Re: Florida Power & Light Company
Proposed Turkey Point Units 6 and 7
Docket Nos. 52-040 and 52-041
Response to NRC Request for Additional Information Letter 120329
(eRAI 6354 Rev. 0) Related to ESRP Section 2.3.1 - Hydrology

L-2012-296
10 CFR 52.3

NRC RAI Number: EIS 2.3.1-2 (eRAI 6354 Rev. 0)

NRC RAI Number: EIS 2.3.1-6 (eRAI 6354 Rev. 0)

Figure 1
Extended Power Uprate Monitoring Well Locations

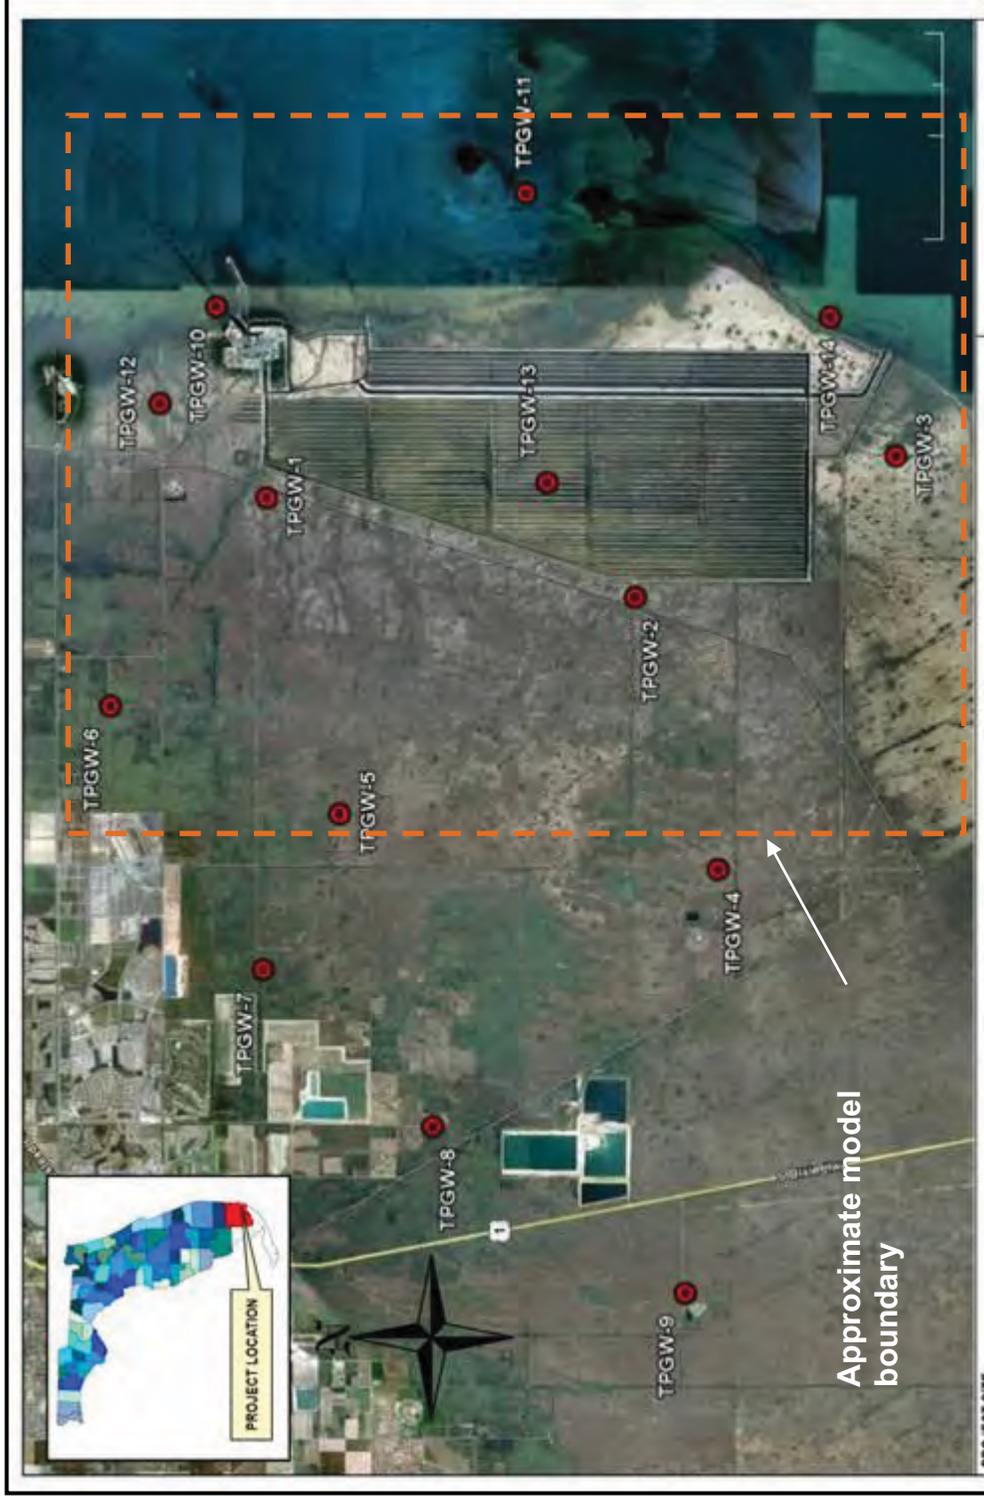
Sampling errors result from the inadequate density, frequency, and duration of measurements used to characterize the environment. The density, frequency, and duration of measurements have been provided either indirectly or directly in the applicant's environmental report and security control assessor information. However, the applicant has not discussed the basis for their implicit assumption that potential sampling errors are not a plausible basis that might change the impact determination. The review team requests that the applicant discuss the basis for this assumption.

The EPU borings, as shown in Figure 1 and designated as TPGW wells (JLA Geosciences, Inc., 2010), were utilized for comparison with the model hydrostratigraphy. Stratigraphic data

from these wells improved the offsite subsurface dataset and were used in the Turkey Point Units 6 & 7 groundwater flow model to qualitatively assess the thickness and extent of layers used in the model. Specifically, the thickness and extent of the Upper and Lower Higher Flow Zones were identified in these borings and compared to the conceptual model hydrostratigraphy, which was already incorporated into the model. The results of this comparison showed agreement between the conceptual model and the newer boring information. This comparison suggests that the boring density used in the conceptual model was sufficient to adequately characterize the subsurface conditions.

**Figure 2C. River Boundary Cells in Model Layer 5 (Upper Higher Flow Zone)
(Plant Discharge Canal)**

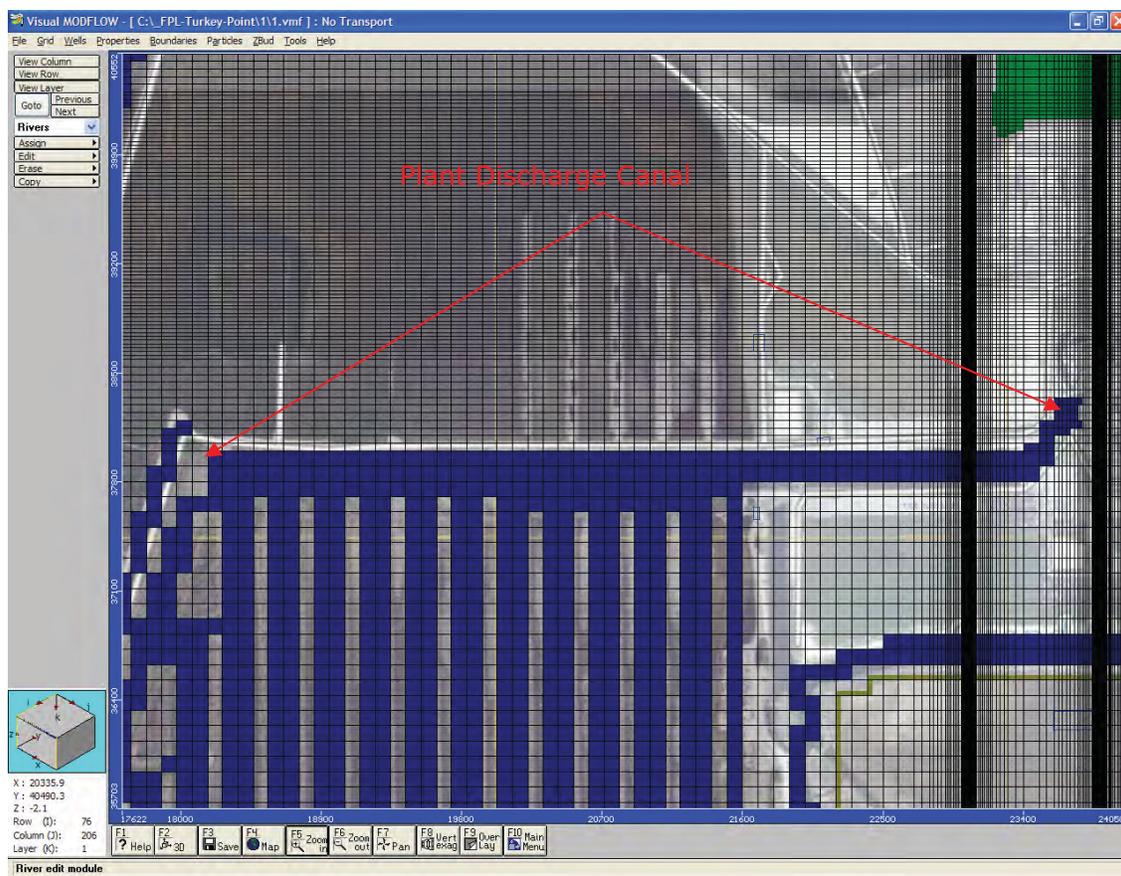
- a. the perimeter boundaries defined as "general head boundaries"
- b. the "river package" boundary between Plant Discharge Canal and the Upper High Flow Zone (Model Layer 4)
- c. the "river package" boundary representing the regional canals and the Interceptor Ditch
- d. the general head boundary at the bottom of Biscayne Bay for each of the materials defined at this boundary (i.e., sandy sediment and rock)

The extent of the Plant Discharge Canal is identified in Figure 2A. River boundary cell locations in Model Layer 1 and Model Layer 5 (Upper Higher Flow Zone) are shown in Figures 2B and 2C, respectively, for the Plant Discharge Canal. Additional river boundary cells are located in Model Layers 1 through 6 of the Phase 2 model (and Model Layers 1 through 5 of the Phase 1 model). Figure 2D shows river boundary cells in Model Layer 5 (Upper Higher Flow Zone) for the cooling canal system.

For example, the calculated conductance for the river boundary cell in Model Layer 5 (Upper Higher Flow Zone) at Row 163 and Column 203 is:

$$\begin{aligned} C &= (K_v \times L \times W) / M \\ &= [1.0\text{E-}05 \text{ cm/s} \times (2835 \text{ ft/day} / 1 \text{ cm/s}) \times 100 \text{ ft} \times 97.94 \text{ ft}] / 0.1 \text{ ft} \\ &= 2777 \text{ ft}^2/\text{day} \end{aligned}$$
